## STUDY on LED replacement light sources introduction into Regulation No. 37

# STUDY on LED replacement light sources introduction into R37

#### Addendum 36 – Regulation No. 37

#### Revision 7 - Amendment 8

#### Examples of the arrangement of the approval mark and specific identification code

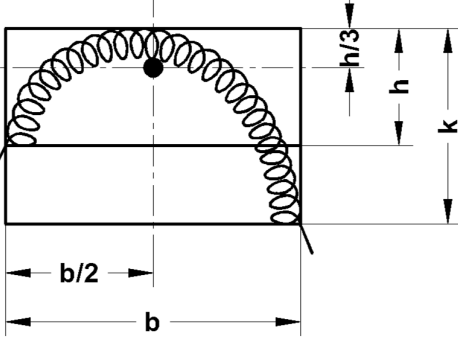
The approval mark above affixed to the light source, preceded by the character "HE", indicates a high-efficiency LED replacement light source that has been approved in The Netherlands (E 4) under the approval code 1953.

The AE device bearing the specific identification code shown above has been approved together with a high-efficiency LED replacement light source approved in The Netherlands (E4) under approval number 1953.
